**CITY OF SEATTLE
ANALYSIS AND DECISION OF THE DIRECTOR OF
THE DEPARTMENT OF PLANNING AND DEVELOPMENT**

Project Number: 2400547

Applicant Name : Scott Clark and Brenda Barnes, Clark Design Group
for Triad Development

Address of Proposal: 3104 Western Ave

Figure D

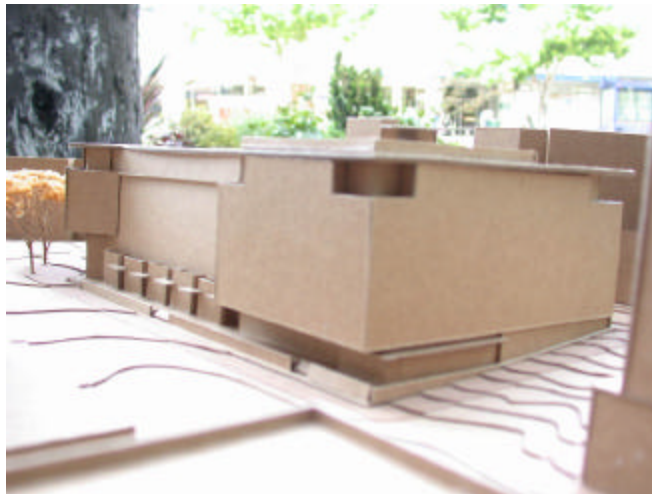
“(See Figures D & E). The canopies respond to the street and pedestrian context. They reinforce the different massing elements and uses along the different facades. We have done that by providing overhead weather protection along Denny Way and at the entry to the parking garage. The live/work entries on Western Avenue have individual entry canopies and the residential entry located on Bay Street has an entry canopy.

Figure F

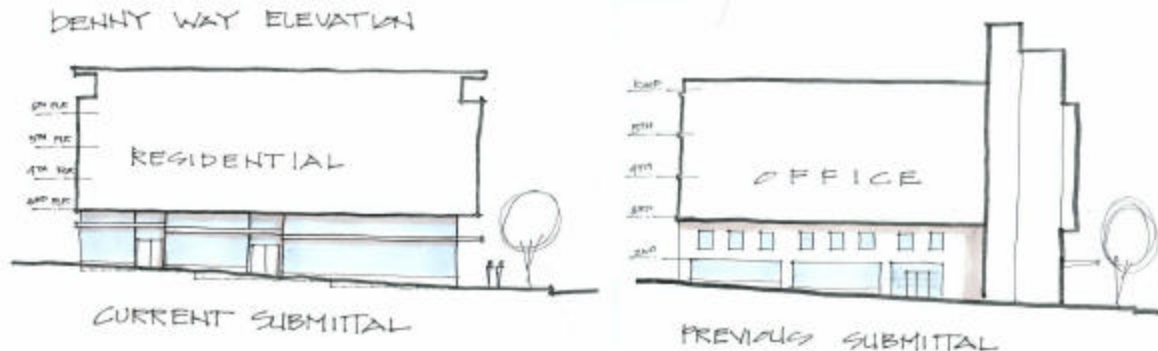
“After reviewing the previous submittal we decided to employ a different strategy. The previous scheme had a second floor at the Denny elevation that resulted in greatly reduced opportunities for the grand level retail. This submittal does not have a second floor at the Denny Way elevation. This allow for a higher, lighter and more transparent ground floor that we think is more sucessful and works well with the overhang at the third floor. (See Figure F).

Figure G

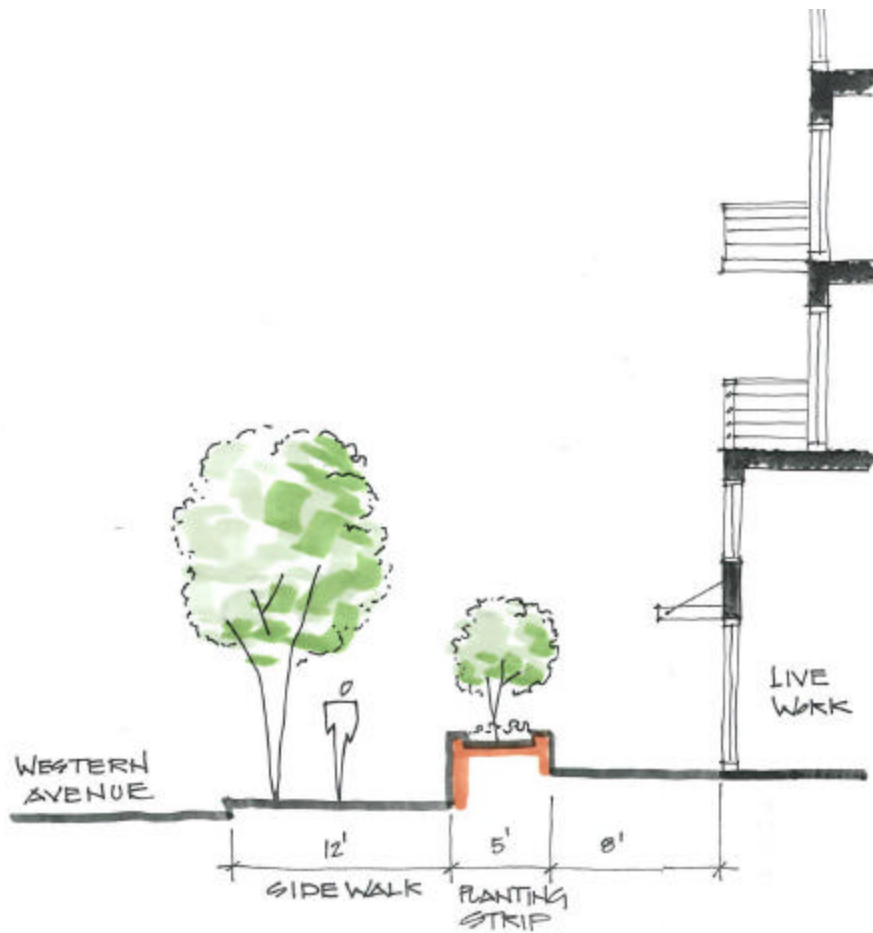
“The live/work entries on Western Avenue have a southern exposure and are separated from the sidewalk by a landscape buffer. Residents may place tables and chairs in this area in good weather. (See Figure G).
